UNITED STATES PATENT AND TRADEMARK OFFICE

APPLICATION NO.	FILING DATE	FIRST NAMED INVENTOR	ATTORNEY DOCKET NO.	CONFIRMATION NO.
10/781,323	02/18/2004	Paul Mantz	AGX-78 (AGXG-7)	9445
22827	7590	01/29/2009	EXAMINER	
DORITY & MANNING, P.A. POST OFFICE BOX 1449 GREENVILLE, SC 29602-1449			CHIN, PAUL T	
		ART UNIT	PAPER NUMBER	
		3652		
		MAIL DATE		DELIVERY MODE
		01/29/2009		PAPER

Office Action Summary	Application No.	Applicant(s)	
	10/781,323	MANTZ, PAUL	
	Examiner	Art Unit	
	PAUL T. CHIN	3652

DETAILED ACTION

Exhibit A

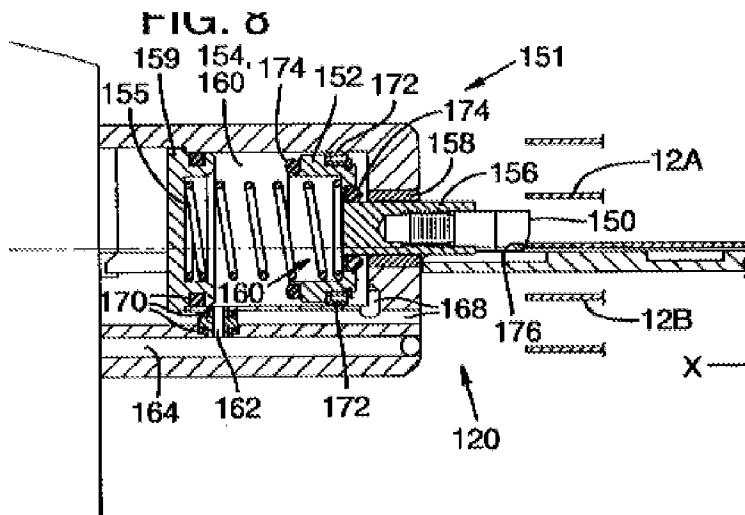
Applicant basically argues that "a spring of Bacchi et al. is to extend an active contact point and vacuum pressure to retract the active contact point". The argument is not persuasive. For instance, claim 1 recites "a biasing member biasing the piston towards a retracted position". Exhibit A teaches an inner piston (159), another piston (152), a pushing device (150), and a spring 155 capable of pushing against the piston 159 towards a retracted position.
